Gate Operations and “Automatic Guard Band” Feature

Christian Boiger
christian.boiger@b-plus.com
IEEE 802 Plenary
July 2015
Waikoloa Village, HI

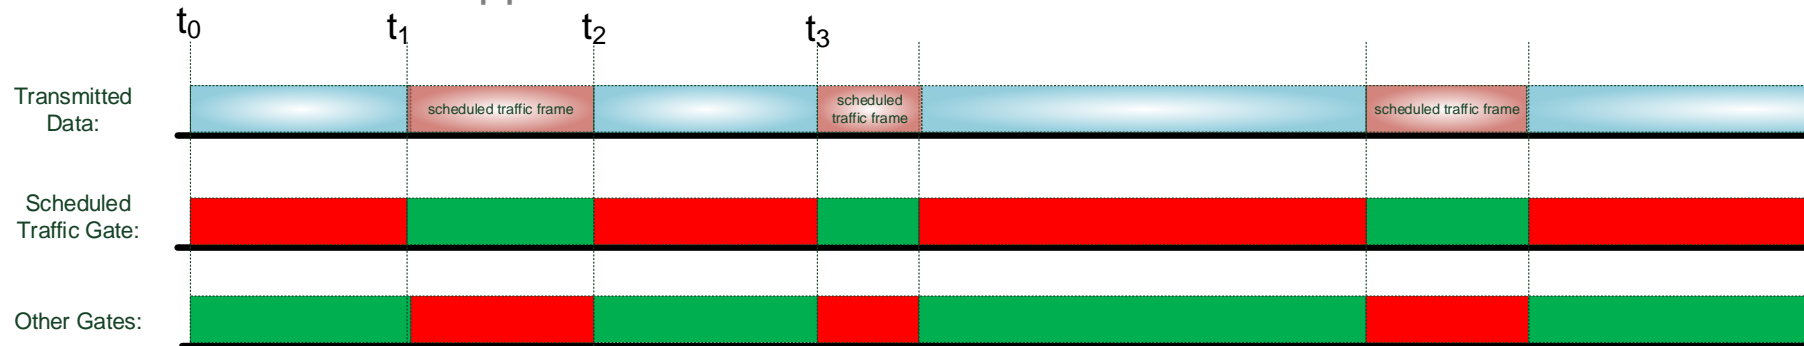
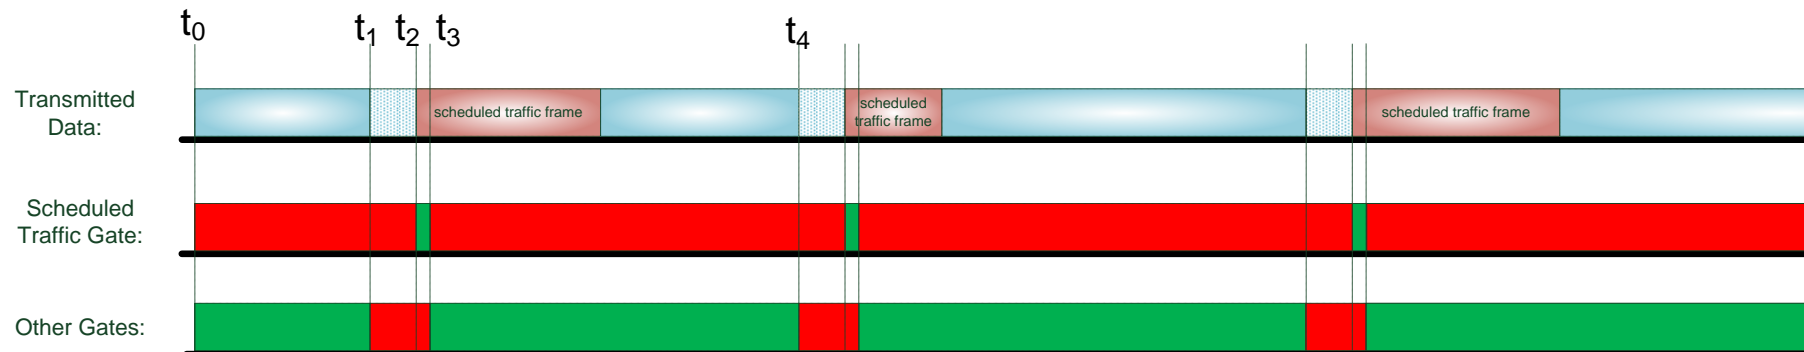
What is the problem with this description?

- The “god box” that calculates the schedule does not know which of the two versions is used by a bridge
- Two different bridges with the same configuration might show two entire different behaviors

- It is very vague
- What does “if the frame size is known” mean?
- My assumption is that a 802.1Q bridge knows the size of a frame (implementations might not), therefore this part seems to be irrelevant from an standards point of view

- What if for some queues the frame size is known and for others not?
- What if the frame size is known for small frames e.g. 64 byte frames but not for bigger frames?

- We should get rid of the “if the frame size is known”
- The “gate approach” shall be mandatory (every bridge that supports scheduled traffic should be capable to support this)
 - This requires almost no changes, in most parts of the document this is already the case, e.g. definition of open and close:
 - “a) *Open*: Queued frames are selected for transmission, in accordance with the definition of the transmission selection algorithm associated with the queue.
 - b) *Closed*: Queued frames are not selected for transmission.”
- Define an optional configurable “automaticGuardBand” feature that covers the “window approach”

In addition to the other checks carried out by the transmission selection algorithm, a frame on a traffic class queue is not available for transmission (as required for tests (a) and (b) in 8.6.8) if the transmission gate is in the closed state or if ~~the frame size is known~~ **automaticGuardBand is active** and there is insufficient time available to transmit the entirety of that frame before the next gate-close event (3.1) associated with that queue.
